WATER PERMIT NO. 6639-3

CENTERVILLE DAM DAM RECONSTRUCTION

TO: Jeff Peters, PE, Division of Administration, SD Game Fish & Parks
FROM: Len Neugebauer, PE/LS *Len Neugebauer*
DATE: September 15, 2005
RE: Hydraulic Review and Comments on Preliminary Plans (DGR#648181, Centerville Dam)

1 in Horiz. = 300 ft 1 in Vert. = 2.5 ft

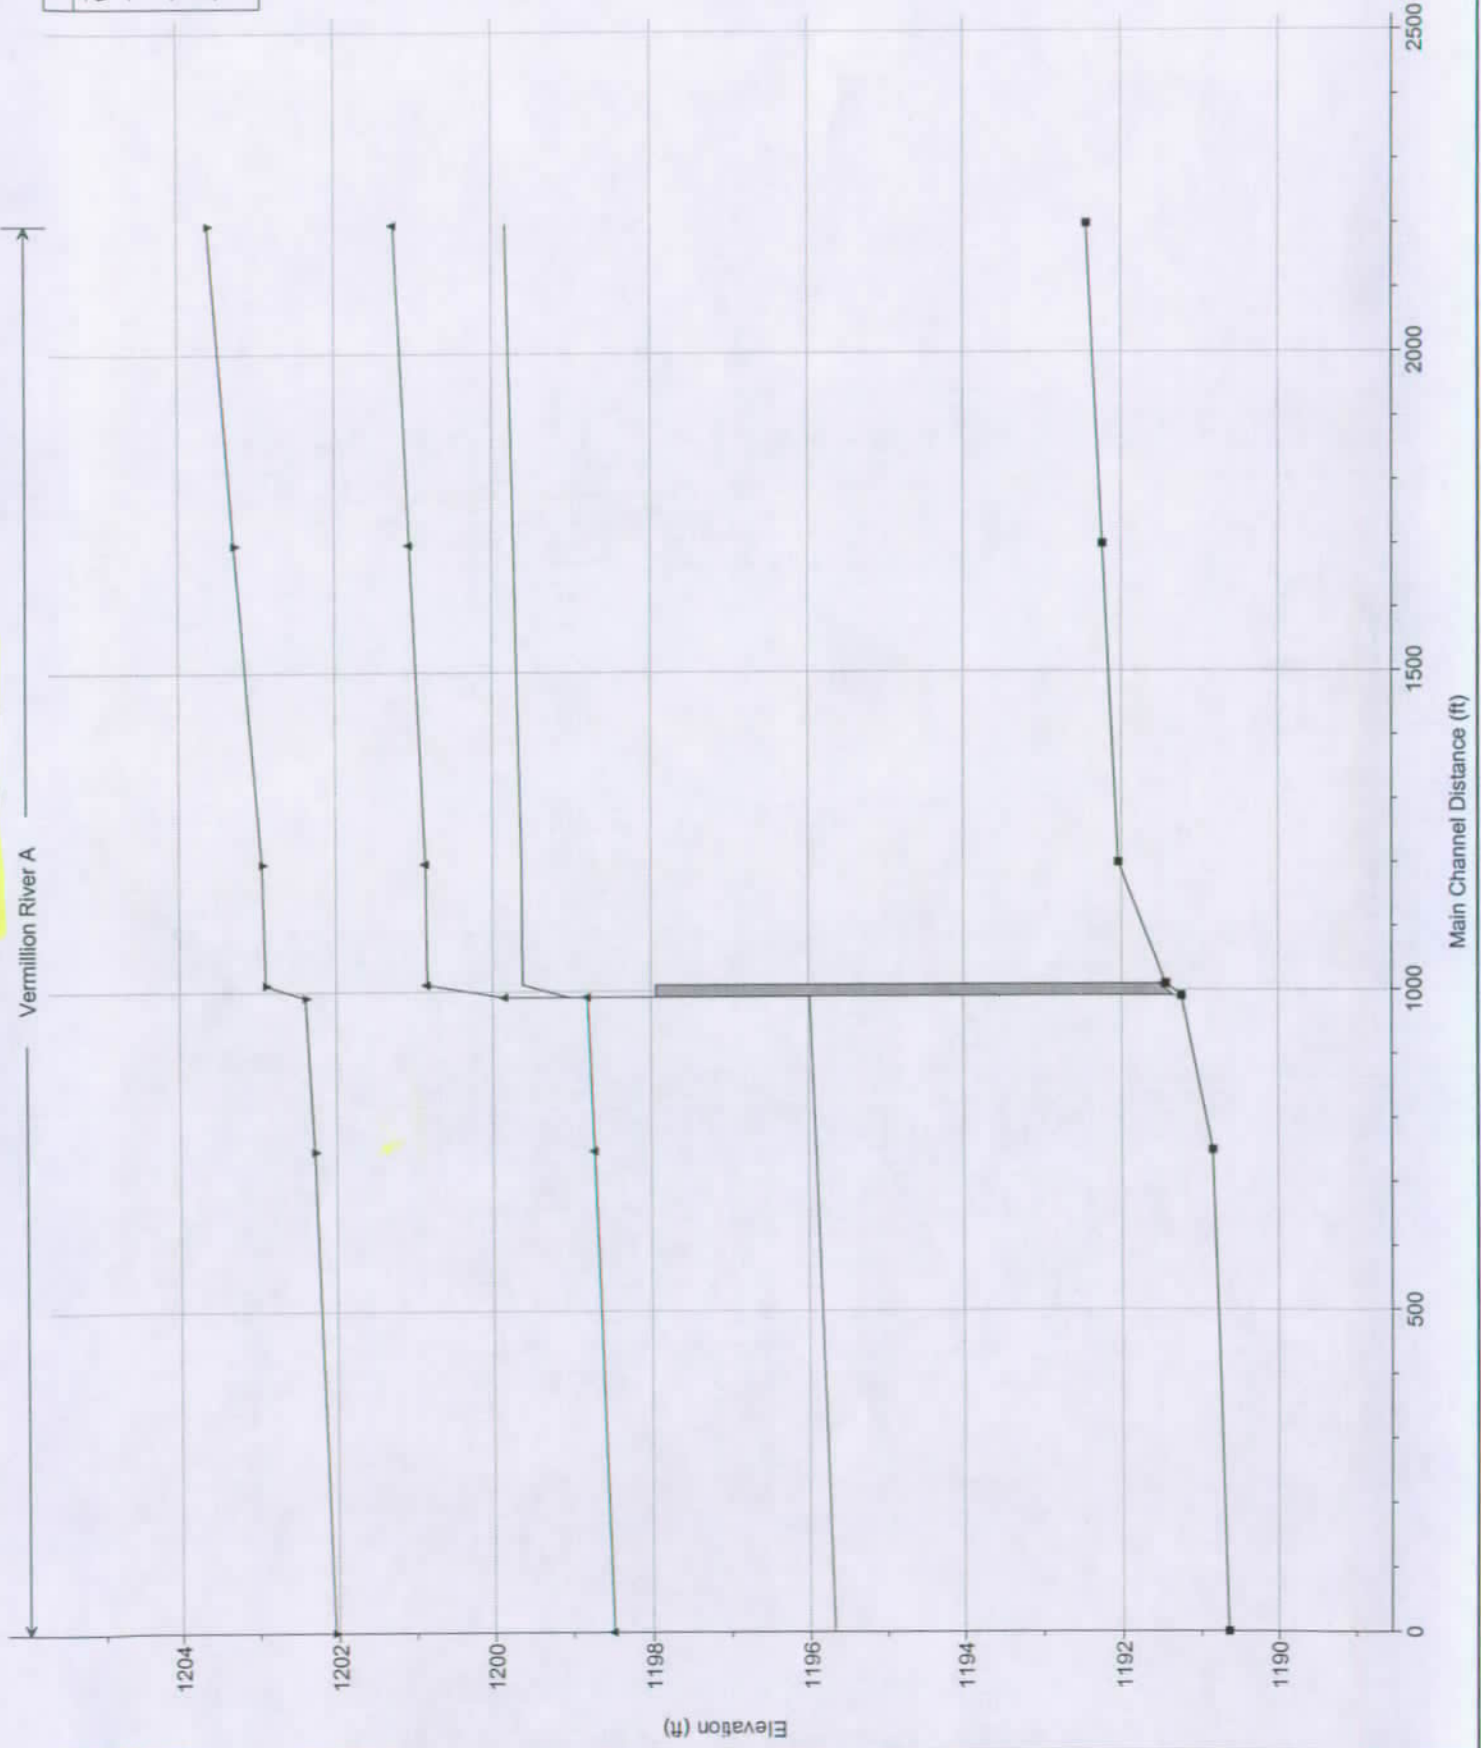
- A. Existing 70' spillway @1198 and existing gate open (prior to dam breach)
- B. Existing 70' spillway @1198 with 90' spillway extension @1198 and existing gate open (DGR Option 2 in our 1999 report)
- ✓ C. Existing 70' spillway @1198 with 80' spillway extension @1199 and existing gate plugged (This is as shown on your preliminary plans for the Centerville Dam reconstruction)
- D. Existing 70' spillway @1198 with 80' spillway extension @1198 and existing gate plugged (This is your preliminary plan modified for the spillway extension @1198)

The flood profiles show the peak water surface elevations (a plot of the W.S. Elev. data shown in the tables which follow the profile plots) and are self-explanatory. Although the water surface elevations computed for your proposed plan are slightly higher than our elevations for DGR Option 2, I believe these slightly higher elevations are acceptable for this dam reconstruction.
